Summit County Planning Commission (SCPC)

Meeting Agenda

1. **Heartridge Subdivision Phase 1 Replat - Replat– Sagamore Hills Township** - Located in Sagamore Hills Township along Hawthorne Drive. Applicant proposes to convert Block B (parcel number 4505603, 0.2662 Ac.) and Block C (parcel number 4505604, 0.3425 Ac.) of the Heartridge Subdivision Phase 1 into S/L 1-98 and S/L 1-99, respectively, with potential future development to occur on both lots.

TITLE SHEET _____ SHEET No. 1

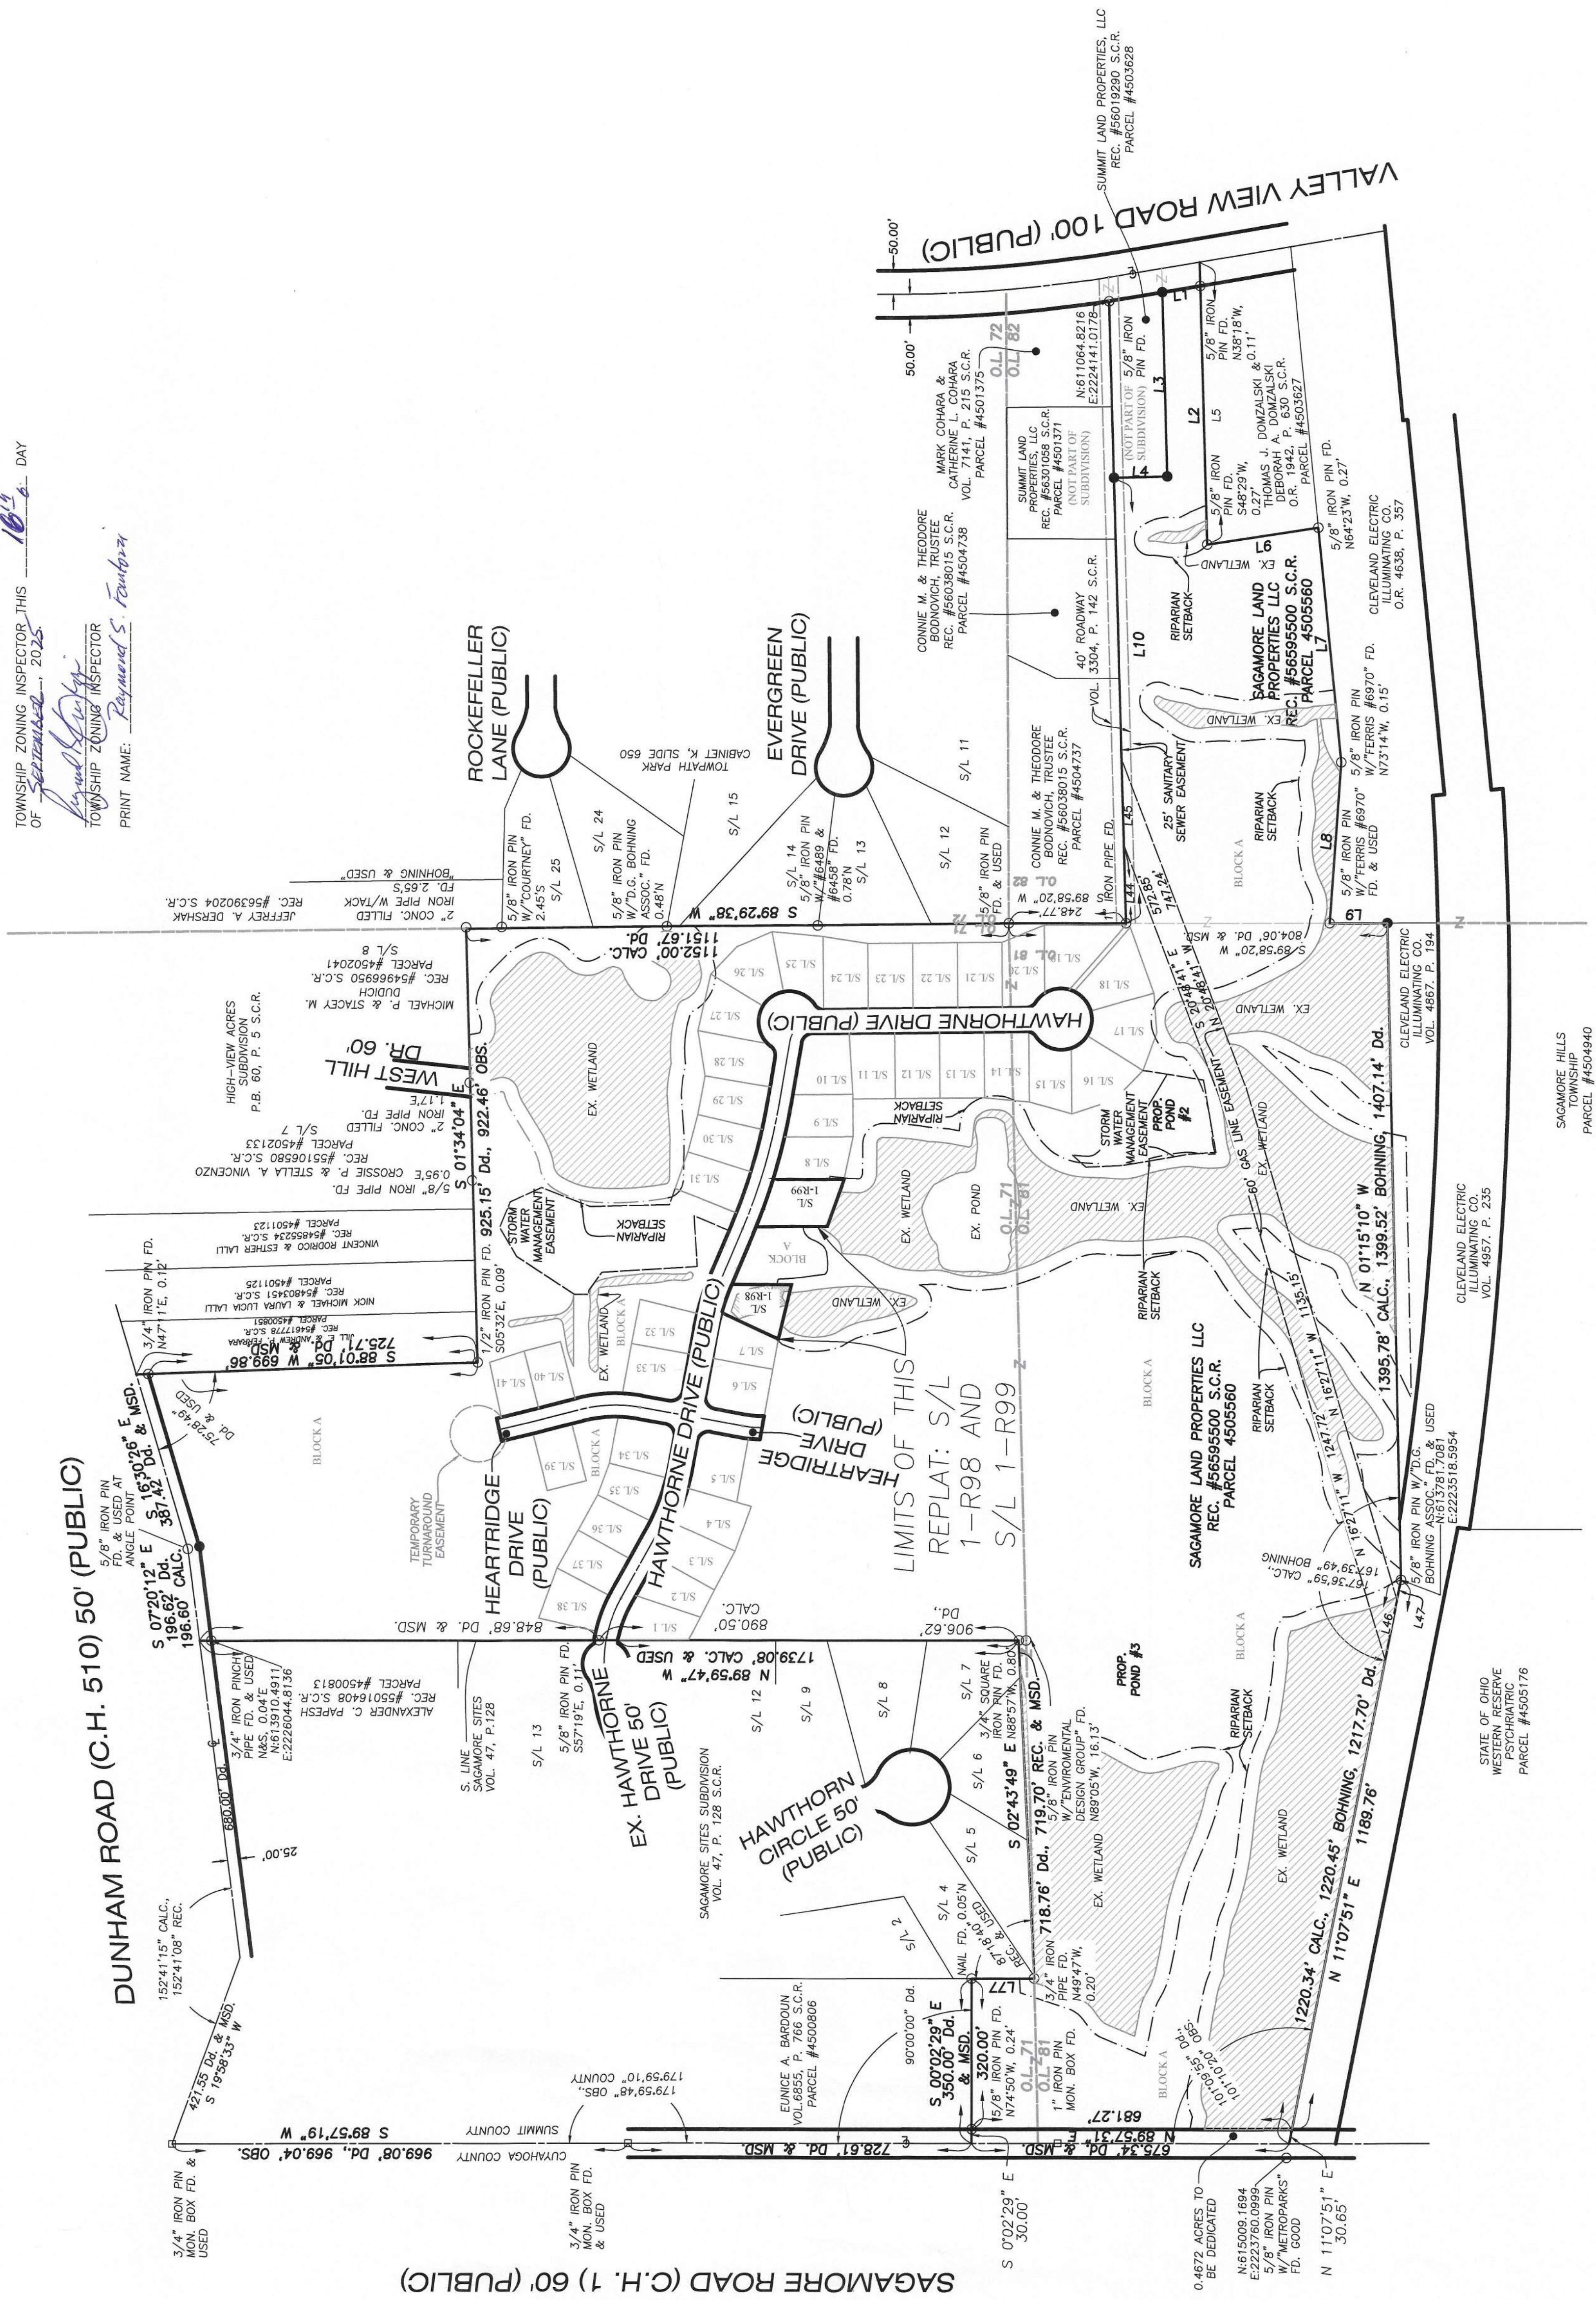
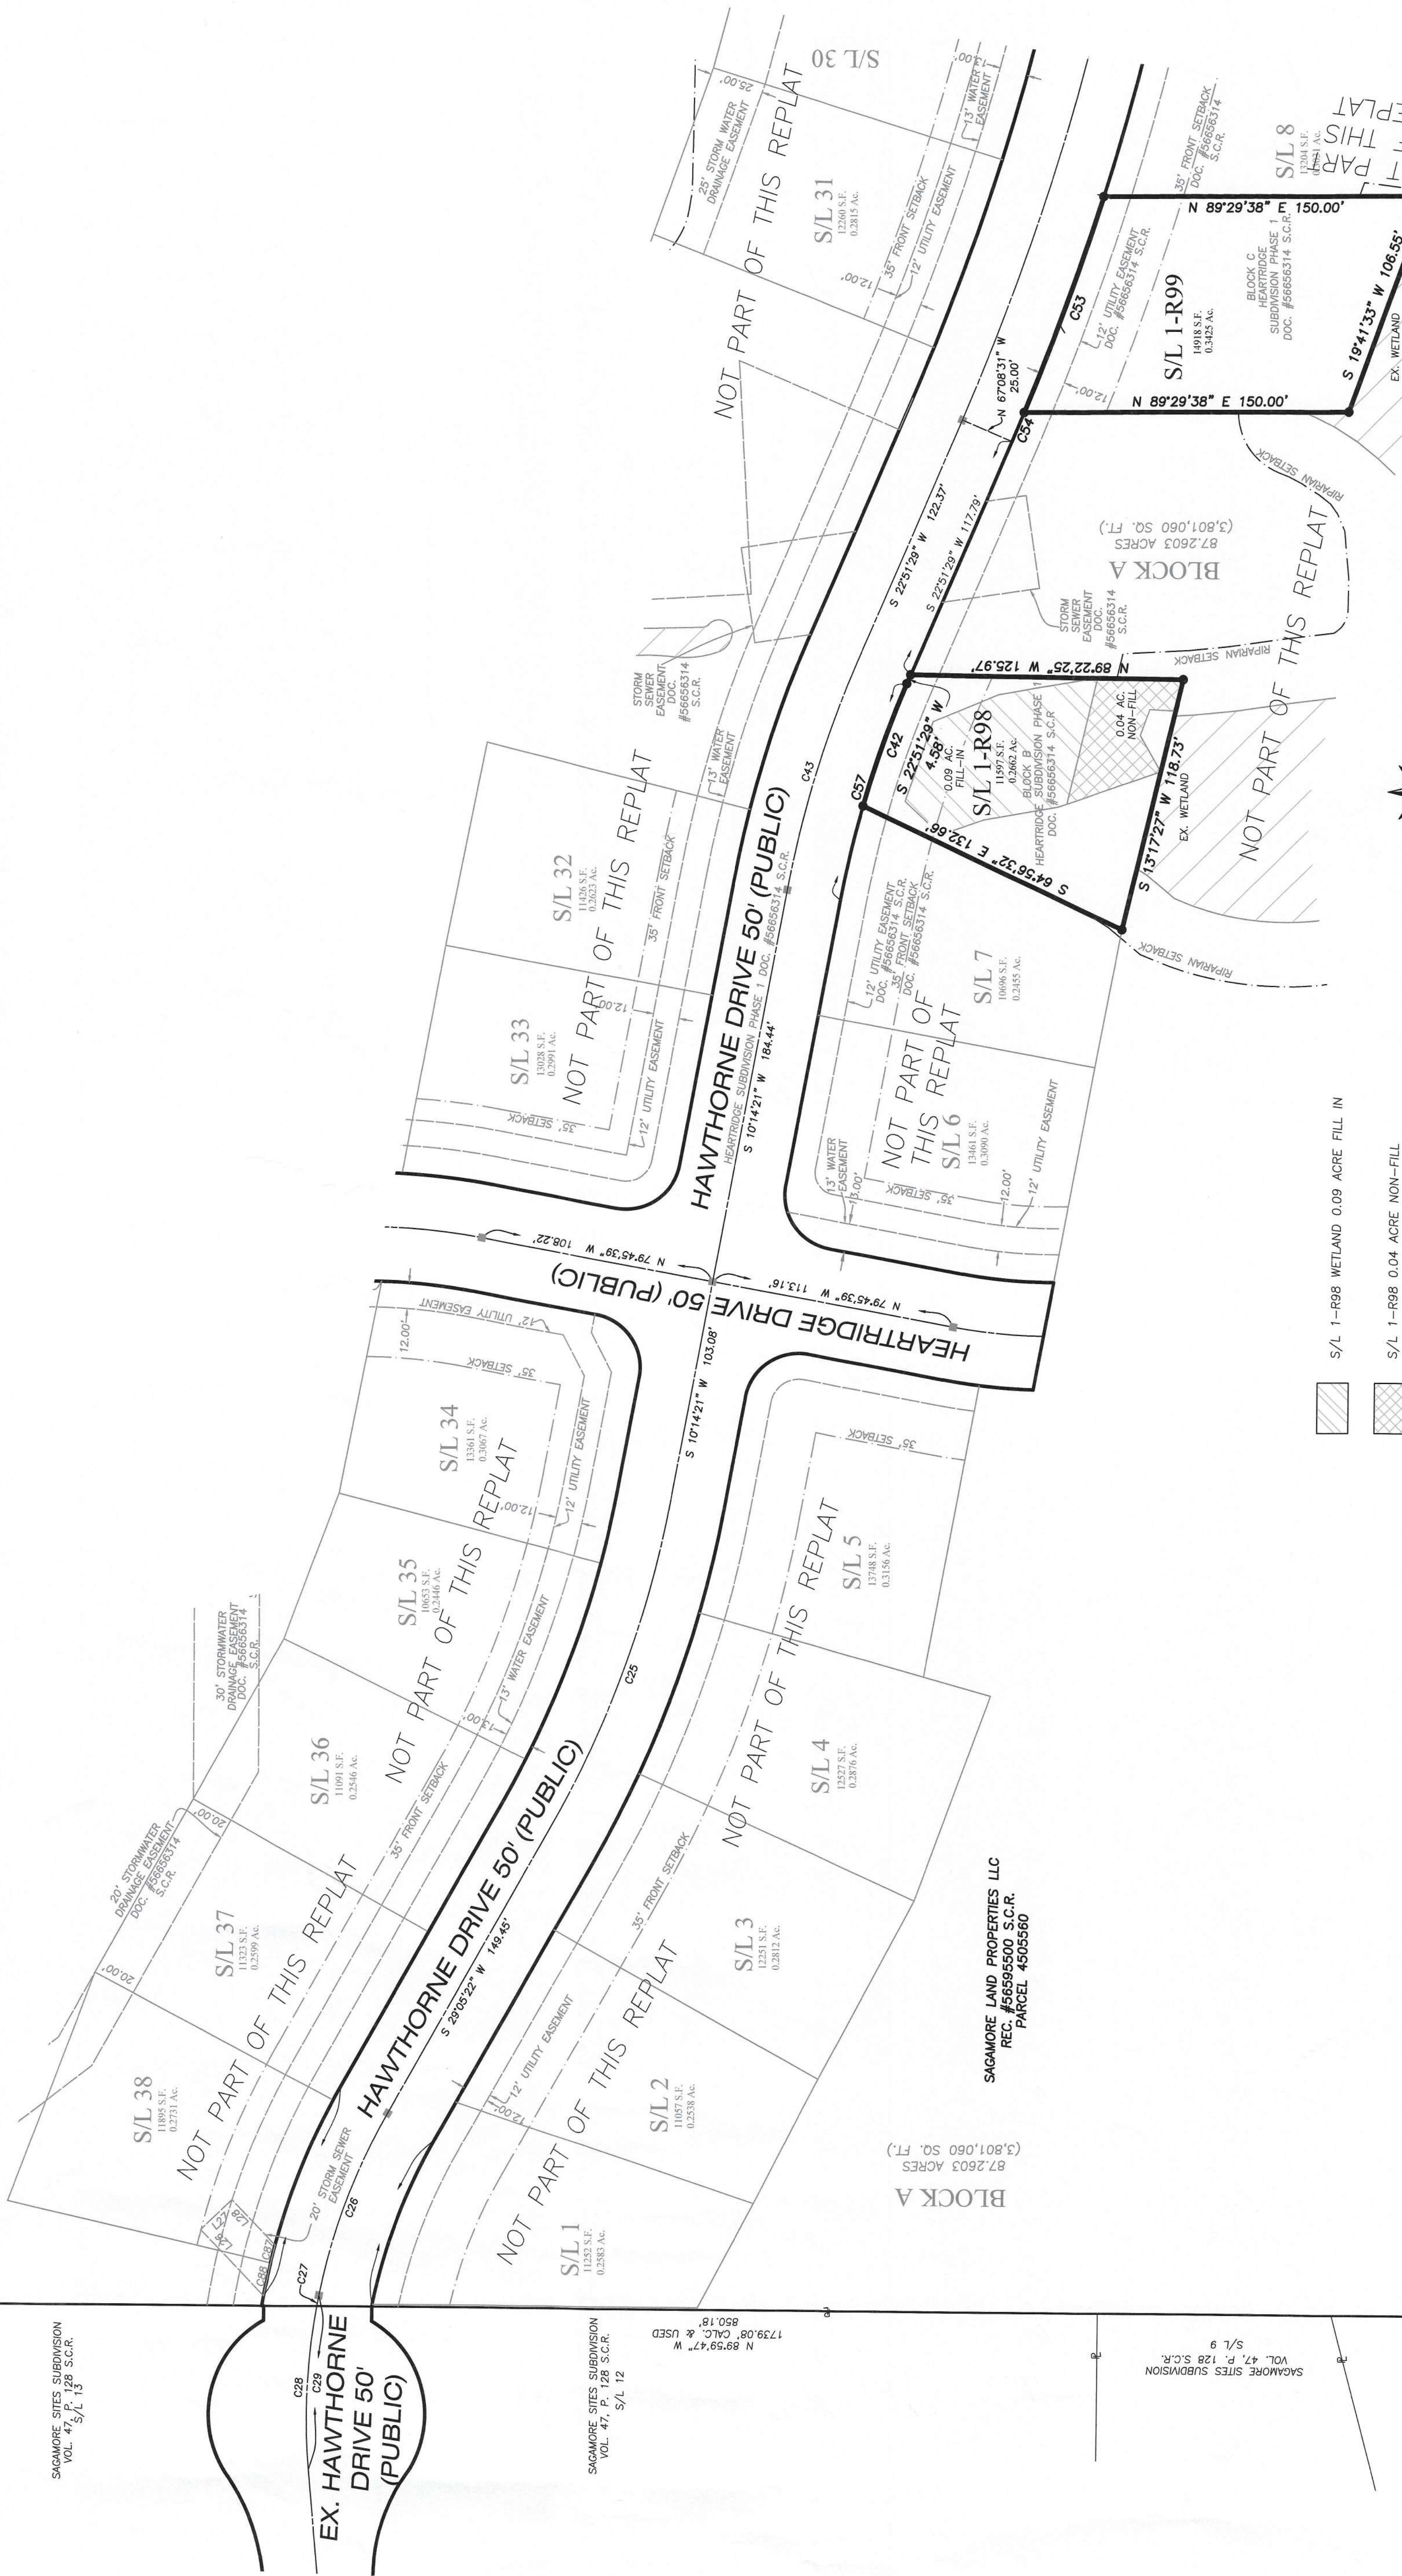
1. *The Sanitary Sewer Lateral locations will need to be defined on the Site Improvement Plans for Proposed Sublots 1-R98 and 1-R99...the Hawthorne Drive Pavement is not permitted to be disturbed to accommodate the Sanitary Sewer Laterals.*
2. *All outstanding Survey related comments have been adequately addressed.*

Recommendation: It is Staff's recommendation that the SCPC **TABLE** this Replat until the applicant delineates any riparian areas within the project area, and request a riparian variance from the Summit County Planning Commission before entertaining this replat proposal, unless the applicant can currently prove that no riparian areas exist within the project area.

Photo taken by:
Peggy & Larry Spraggins
Feb 25, 2025 12:13 pm
Block B

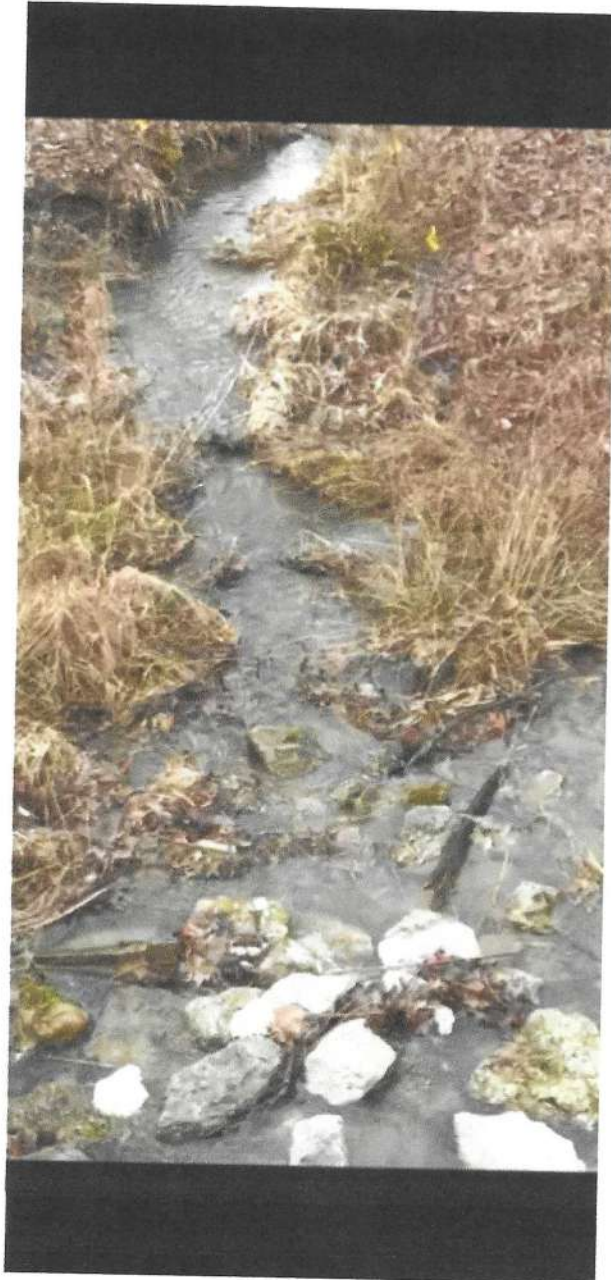
Based on the above facts, a reasonable person would be able to determine that Blocks B and C are still wetlands and to allow development on either parcel would be detrimental to the surroundings parcels and neighborhood in general. We therefore request that the Summit County Planning Commission deny the application for a replat of Heartridge Phase I.
